Oconee Nuclear Station Units 1, 2, and 3 Docket Nos. 50-269, 270, and 287

Response for Additional Information for Technical Specification

3.8.1, "AC Sources - Operating"

Technical Specification Change (TSC) 2005-07

Figure 1

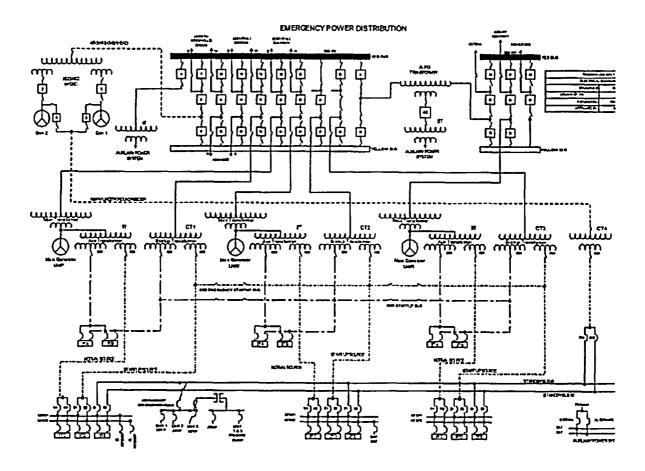
RAI #1: Please provide brief description of onsite and alternate ac (AAC) power source.

Duke Response: An offsite power system and an onsite power system are provided for each unit at the Oconee Nuclear station to supply the unit auxiliaries during normal operation and the Reactor Protection System and Engineered Safeguards Protection Systems during abnormal and accident conditions.

Each Oconee unit has six available sources of power to the Engineered Safeguards Systems as shown in the following figure (Figure 1). These are:

- The 230 kV transmission system and/or the 525 transmission system
- Two Keowee hydro units
- The 100 kV transmission system
- The two other nuclear units

The normal arrangement is for three of these to service any or all units and to be switched in the preferential order as follows: (1) the 230 kV transmission network through the unit startup transformers, (2) one Keowee hydro unit through an overhead 230 kV circuit, and (3) the other Keowee hydro unit through an underground circuit.

Whenever the underground circuit from Keowee is unavailable, a circuit from the 100 kV transmission network can be connected to the Standby Buses and serve as an emergency power source.

Any unit can provide power to another unit's Auxiliary System via the switchyard.
